# SITE 20/24 RECORD OF DECISION

FINAL

##### 3.1.1 Summary of Comments Received during the Public Meeting on the Proposed Plan and Agency Responses

REVISION NO.: 1	DATE: 10/26/99	ACAD FILE: 102699ASSCAP.dwg
<b>SITE 20/24</b> <b>SOIL COVER/ASPHALT CAP</b> <b>CROSS SECTIONS</b>		
DET'D: AS	CLIENT: PICATINNY ARSENAL	PROJECT NO.: 66719-304-00
CHK'D: LM	LOCATION: DOVER, NEW JERSEY	FIGURE NO.: 2-5

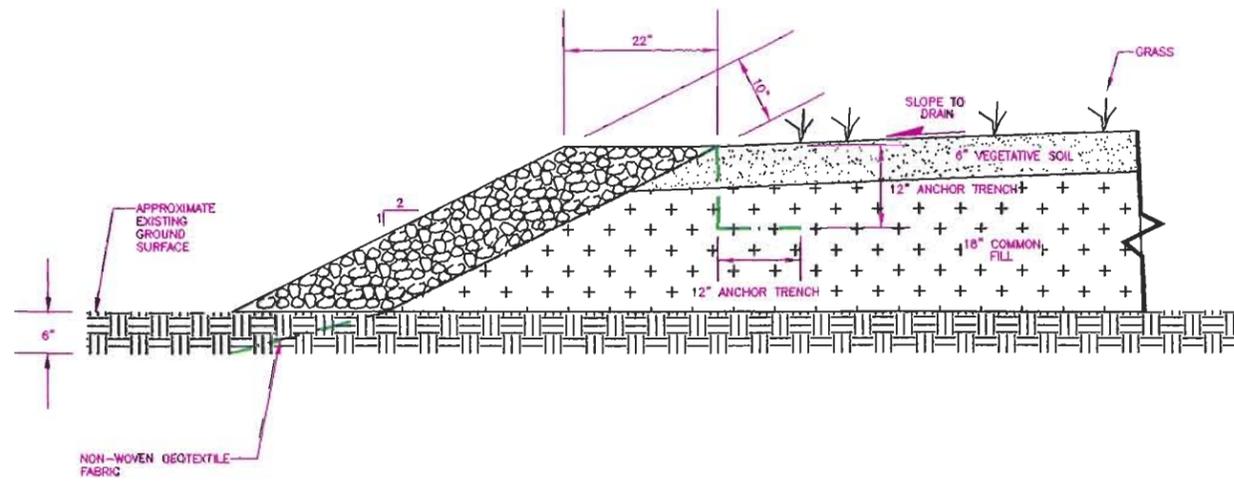
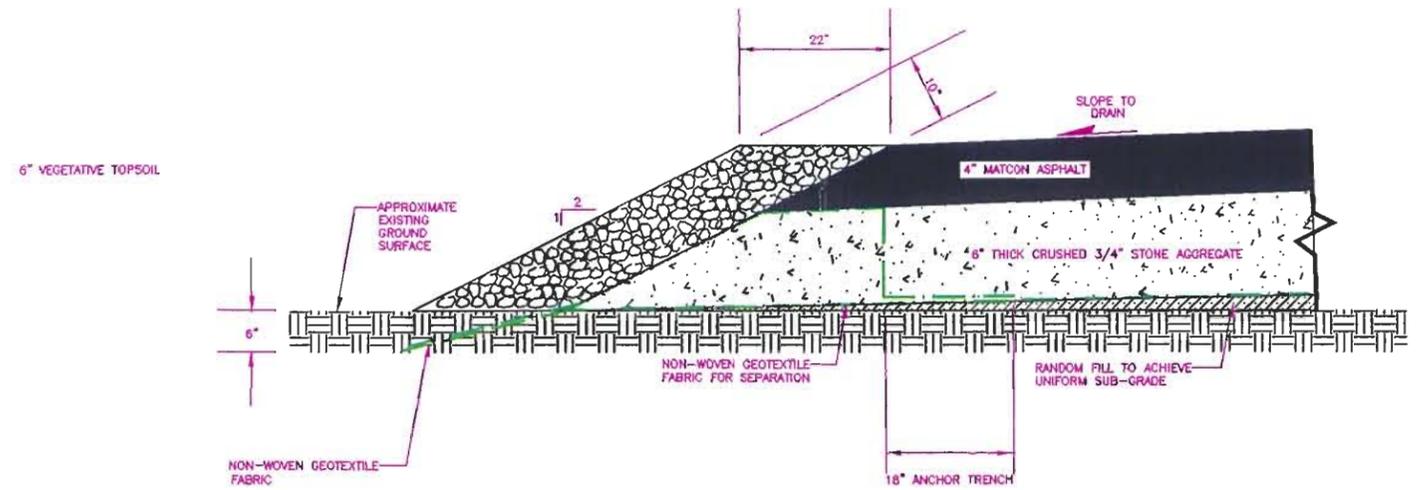
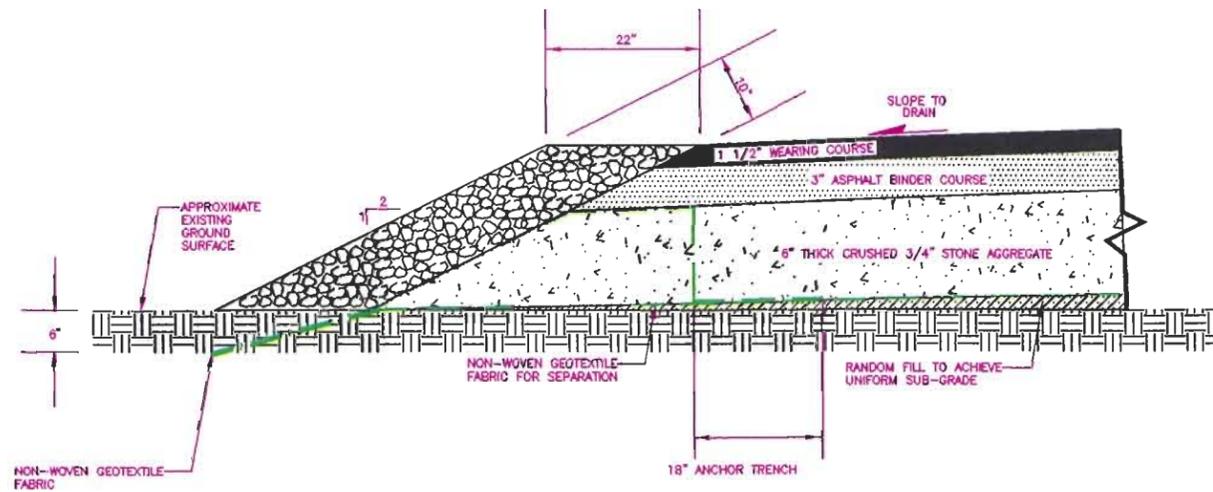
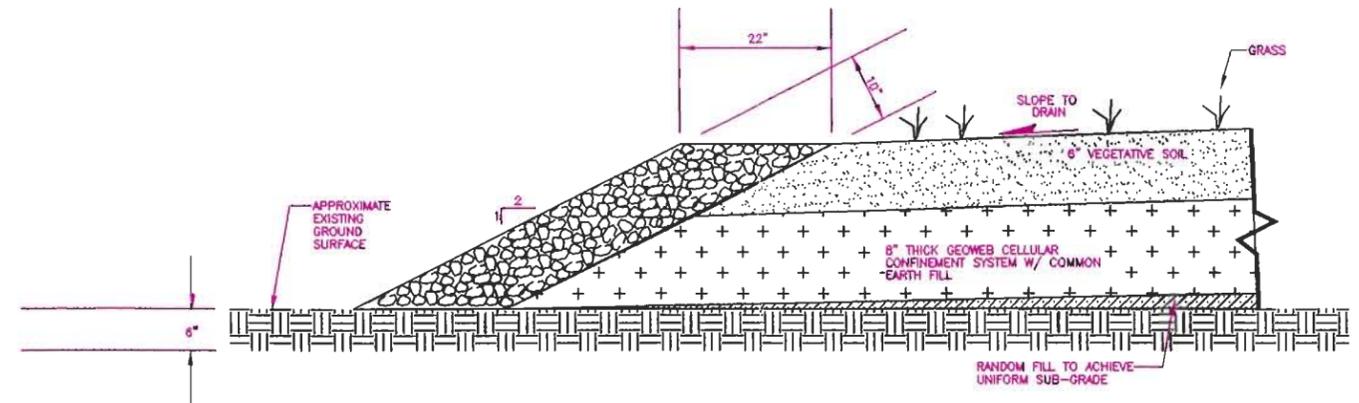
**Comment 4:** Mr. Crothers expressed another concern that Site 20/24 was in a flood zone. There is a lot of moisture. The area from time to time has a very high water table, and that water comes up from underneath the ground.

**Reply:** The area does have a high water table and parts are in the 100-year floodplain. Therefore, the soil cover will be designed to handle a 100-year flood and will be monitored four times a year (see p 2-17 maintenance). Cap design requires rip-rap armor protection to maintain its stability (see p 2-16 and figure 2-5).
